Product Change Notification

Date Issued :	July 03, 2023	PCN Number :	513793
Reason for Change :	Change to Product		
Description of Change :	Change dimension of free ends from 50 +5/-0 to (38,1) mm. Adding isolation of free ends (9.7) mm.		
Reason for Short Notice :	Special Request		
Assessment of Change :	First Article Inspection		
Planned Implementation Date :	August 11, 2023		
Sample Availability Date:	July 07, 2023		
Internal Molex Qualification Date :	July 21, 2023		
Last date to request Samples by Customer :	July 03, 2023		
Traceability Code Markings / Date :	No special marking on the product or packaging

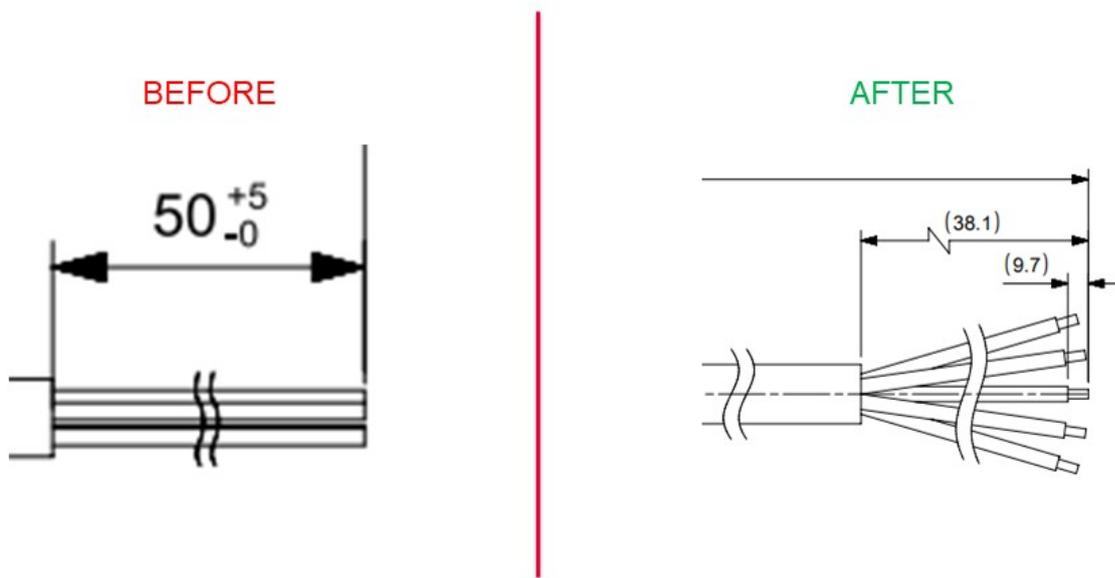
- Change dimension of free ends from 50 +5/-0 to (38,1) mm. Adding isolation of free ends (9.7) mm.
